Date September 27, 2021 **Report No.** 2021-634

To Chair and Members
Brantford Heritage Committee

2.0 Topic **Proposed Alteration to 135 Brant Avenue, a Property Designated under Part V of the Ontario Heritage Act – Application HA-07-21 [Financial Impact – None]**

Figure 4: Side view of proposed new landing and stairs. Source: Applicant.

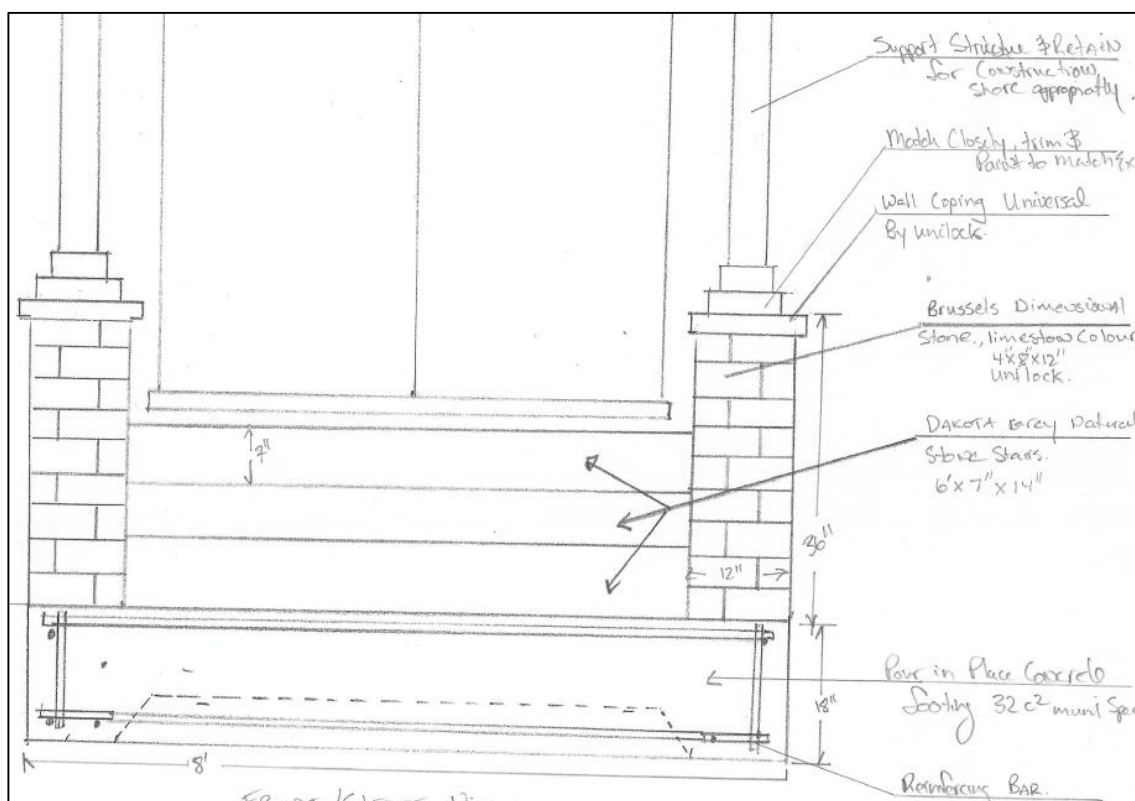
As proposed, the new front porch landing and stairs will have a similar scale to the existing landing and stairs. The Applicant’s proposal maintains the general design and proportions of the existing porch and reuses the existing columns and roof, keeping views of the main entrance open and clear rather than shrouding it. The use of stone for the stairs implements the District Study’s guidelines regarding the use of traditional materials and the use of the same paving stones for the front walkway and the surface of the front porch landing ties the entire porch and front entrance together with the front walkway. The Applicant’s contractor noted that due to deterioration, many bricks cannot be salvaged for re-use from the existing porch. As a result, the Applicant is proposing to use a precast concrete masonry product that resembles stone for the new side walls in a grey colour to match the stone stairs. This use of precast concrete masonry is limited and is in keeping with District Study guidelines. Based on the foregoing, Staff is of the opinion that the proposed alteration is

Figure 5: Sample of proposed pavers in tan-grey colour proposed by Applicant. Source: Manufacturer's Website.

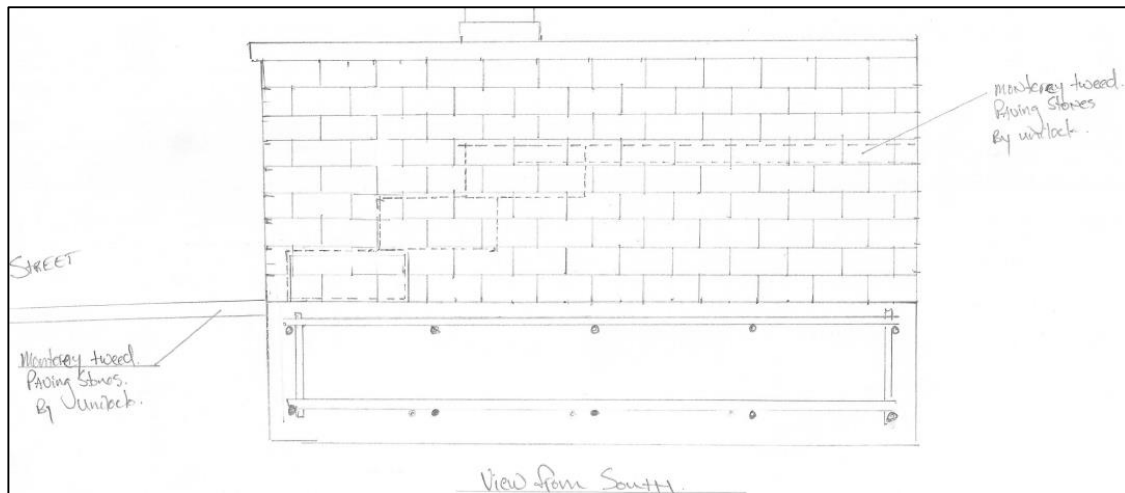
The Brant Avenue Heritage Conservation District (the “District”) Study contains design guidelines and recommendations for maintenance, alteration, and new construction within the District. The District Study notes that porches are an integral feature of many buildings within the District and the guidelines recommend that porches be used to enhance the prominence of the building’s front entrance and match the scale of the building, rather than shroud or conceal the front entrance. Furthermore, the design and placement of the front walkway should have a relationship with the front entrance and porch. With respect to materials, the District Study’s guidelines recommend the use of traditional materials like brick and stone, though other materials can be used in limited capacities.
